Work Order ID 164368***164368***

Item ID: 646.3013 Accept ***N900040100*** Setup Start ***NS1***
Revision ID: Stop ***NS2***
Item Name: Blade
Start Date: 7/28/2017 Start Qty: 10.00 ***10*** Cust Item ID:
Required Date: 8/11/2017 Req'd Qty: 10.00 ***10*** Customer:
Reference:

APICAL INDUSTRIES, INC.	ENGINEERING CHANGE NOTICE NO. 02195		SHEET 1 OF 4	
	DWG NO. 646.3000	REV: N/C	PREPARED BY S. HUFF	DATE: 01/05/09
	EFFECT ON DWG ☐ INC. ☒ UNINC.			
DWG TITLE: LOWER CUTTER ASSY				
APPROVED BY: ENGR <i>[Signature]</i>	MFG <i>[Signature]</i>	QC <i>[Signature]</i>	EFF:	NEXT ORDER
REASON: REMOVED RIVETS IN FAVOR OF ADDITIONAL SCREWS				
TRANSACTION CODES (TC): A-ADD C-CREATE R-REVISE D-DELETE

SHEET 1, ZONE D5, IS:

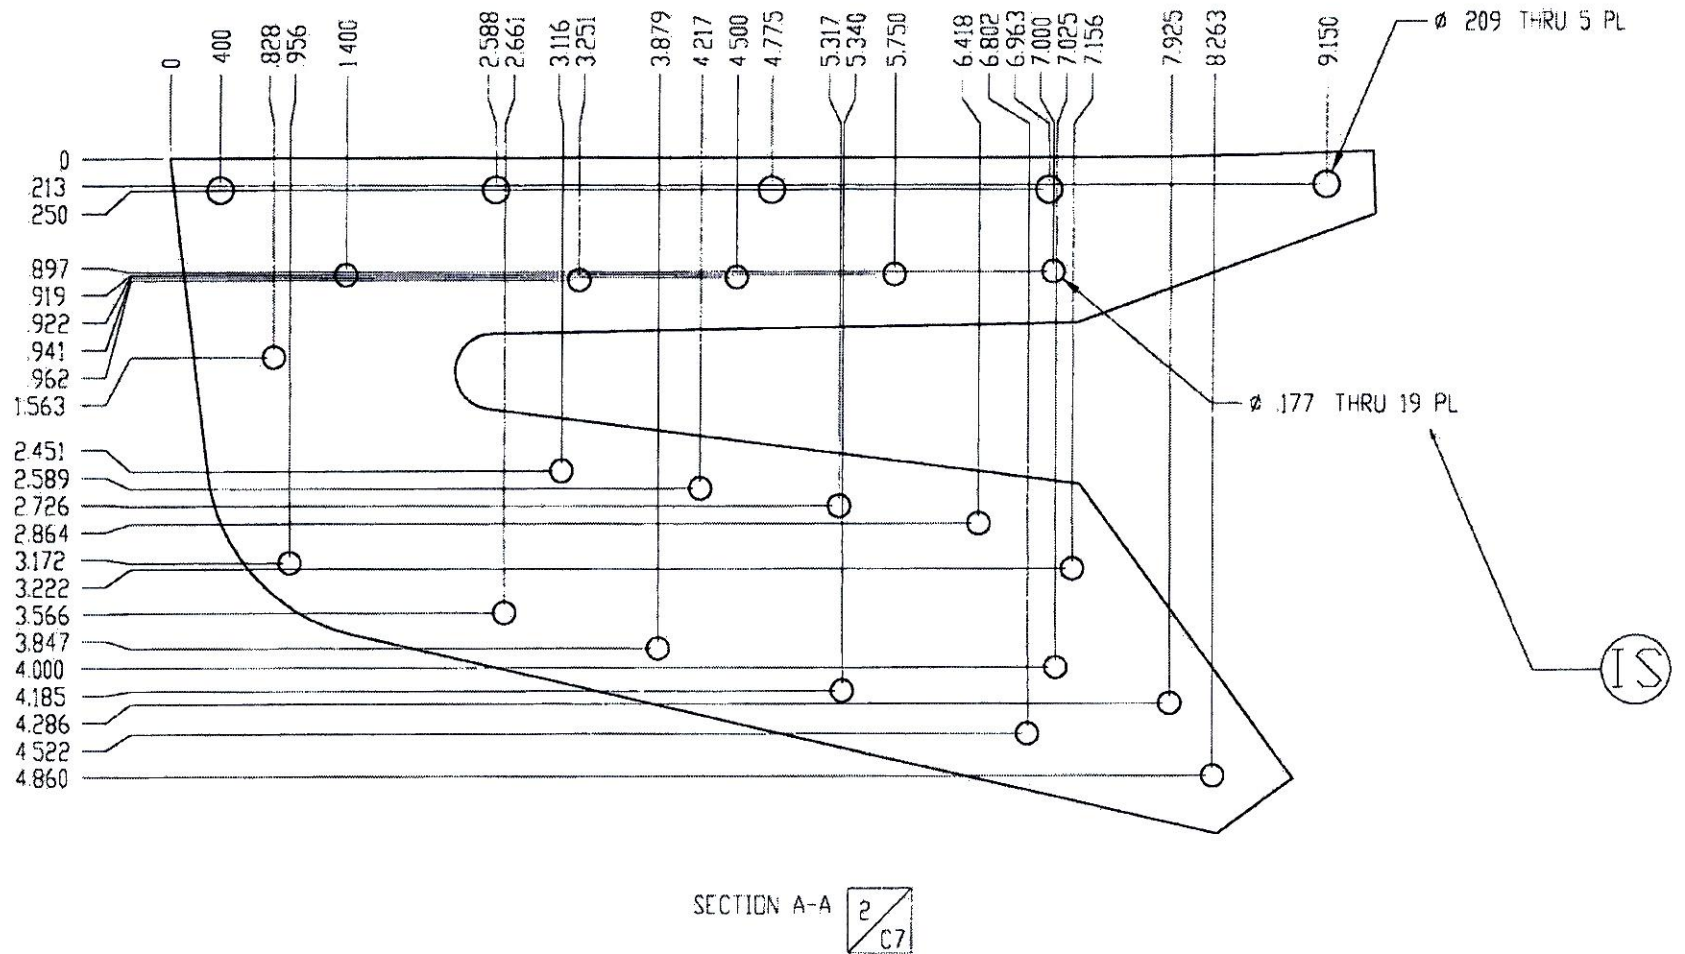
10	R	601.1541	19	LOCKNUT	MS21042L08
9	R	601.2764	38	WASHER	NAS1149FN832P
8	R	601.2765	19	SCREW	MS27039-0819
7	D	601.2766	2	RIVET	MS20470AD5-18
			.3001		
F/N	TC	PART NUMBER	QTY	DESCRIPTION	MATERIAL/SPECIFICATION
DOCUMENTS EFFECTED:					
☐ MDL ☒ INSTALL INSTRUC ☒ ICA ☐ FMS ☒ BOM					
CHANGE CATEGORY ☐ MAJOR ☒ MINOR					
DER REVIEW REQUIRED ☐ YES ☒ NO
